Technical Design Note

Project: Huntlee
Subject: Response to TfNSW Sidra review
Date: 14 June 2022
Attention: Glenn Swan

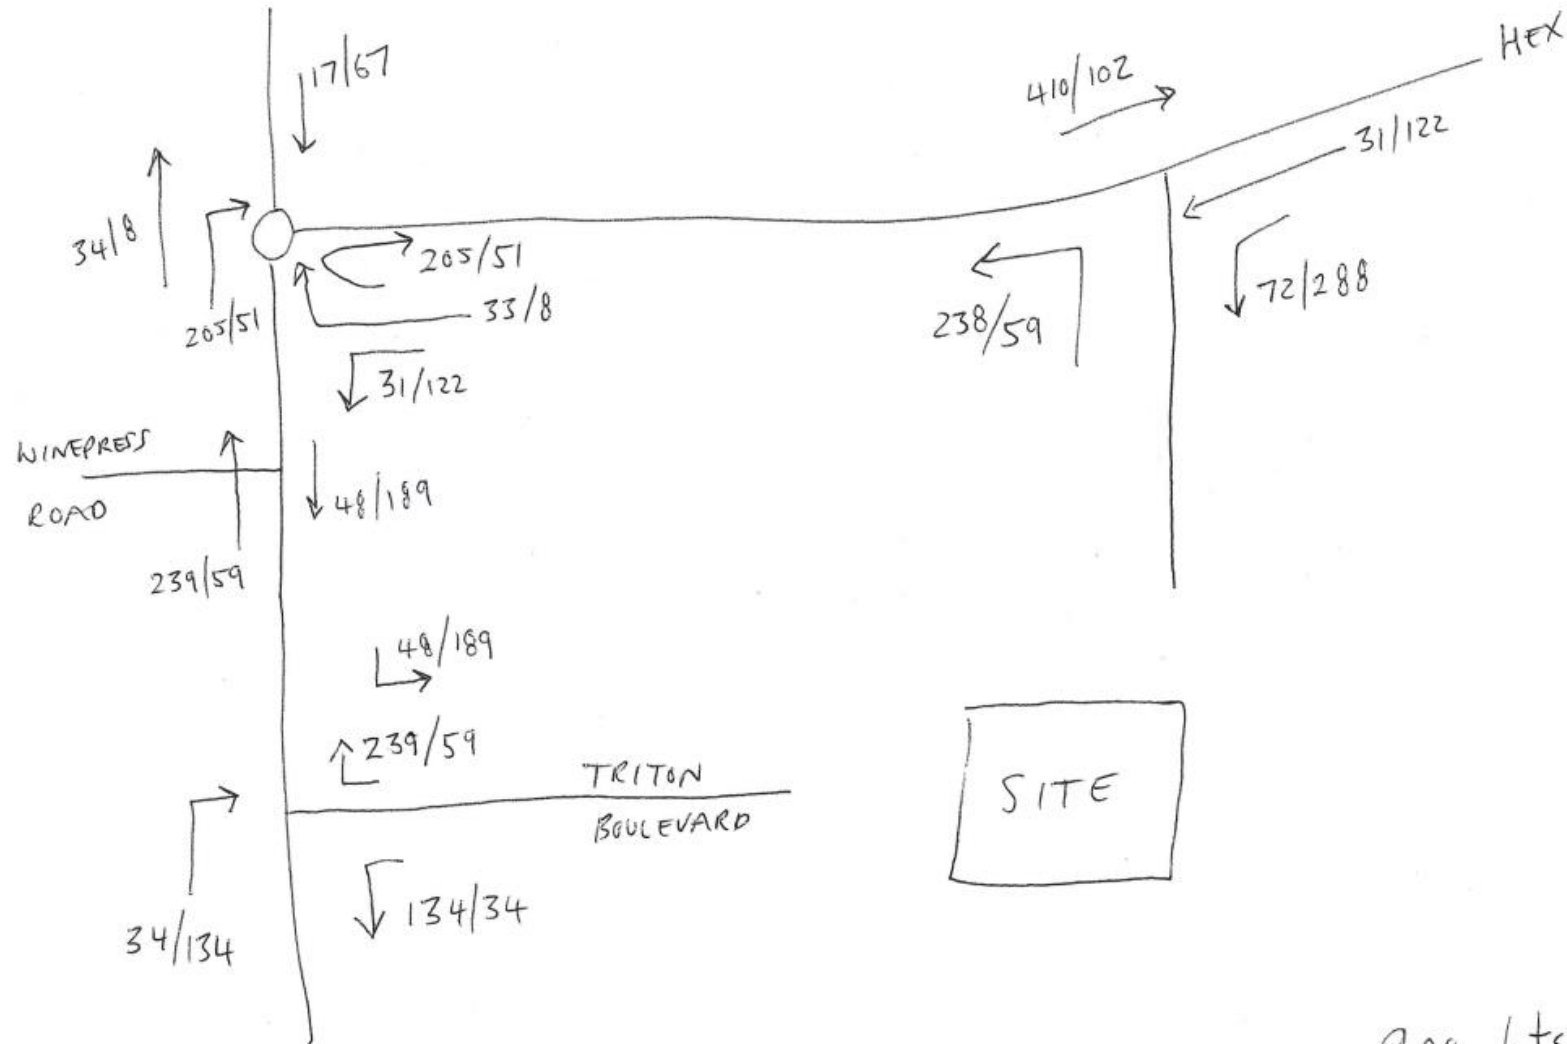
We request the proponent to provide calculation of the future flows (both for the additional 900 lots and additional 1350 lots scenarios) - trip generation calculations and the trip distribution assumptions out of/into the 4 intersections modelled. The values shown in the last image 'Predicted Generated Flows (1350 lots) AM/PM' in the technical design note does not match up with what has been inputted into SIDRA.	Updated calculation flows provided below.
We request that the proponent provide justification of the changes to the default growth rate (specifically the growth rates adopted) - is this for sensitivity testing?	2% background growth applied in updated Sidra model. This is considered realistic in this location with the majority of the development in this location being

Traffic calculations and assumptions:

- 0.85 trips per lot as per original model
- 80% outbound AM and 20% inbound AM
- 20% outbound PM and 80% inbound PM
- 11% of trips to / from Cessnock to south shall use Triton Boulevard interchange

- The 11% of trips to Branxton will be split 5.5% via the left turn out onto HEX then right at the WCD roundabout. 5.5% will turn right out of Triton Boulevard then straight through WCD roundabout

- Of the 67% of trips FROM the Hunter Expressway, 47% shall turn left into the site via the new connection and 20% shall continue through to the roundabout, turn left then left again into Triton Boulevard.

- Of the 67% of trips TO the Hunter Expressway, 33.5% shall turn left onto the HEX then complete a U-turn at the roundabout to head back along the HEX link to the Hunter Expressway. 33.5% shall turn right out of Triton Boulevard, then right at the WCD roundabout to then travel along the HEX to the Hunter Expressway.
